# CONCEPT DESIGN ENGAGEMENT REPORT FREDERICK STREET PARK

2023

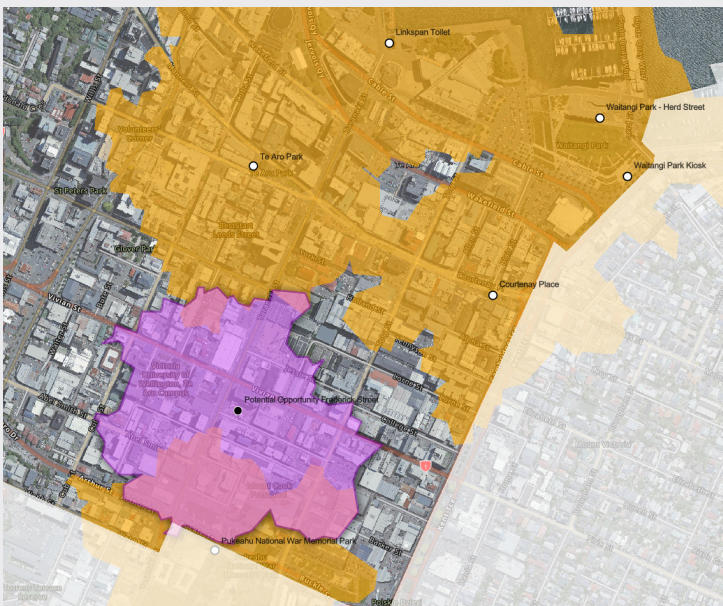
In general, people support public toilets to make the park more accessible. There have also been concerns raised around public toilets attracting anti-social behaviour.

- *"Love the bike parking, toilet and drinking fountain, all essential when my kid is with me."*
- *"from my experience as an inner-city resident public toilets attract crime, drug deals etc"*
- *"Public toilet also, yay!"*
- *"pleased to see supportive seating and toilets have been included in the current plan"*

With accessibility being a priority for this project, the provision of public toilets makes these spaces more accessible for many people including those who are elderly, disabled or with children.

There is a gap within the inner city public toilet network, as illustrated in the map below. The proposed public toilets in the Frederick St Park project would help to fill this gap in the network, providing for the catchment area illustrated in pink.
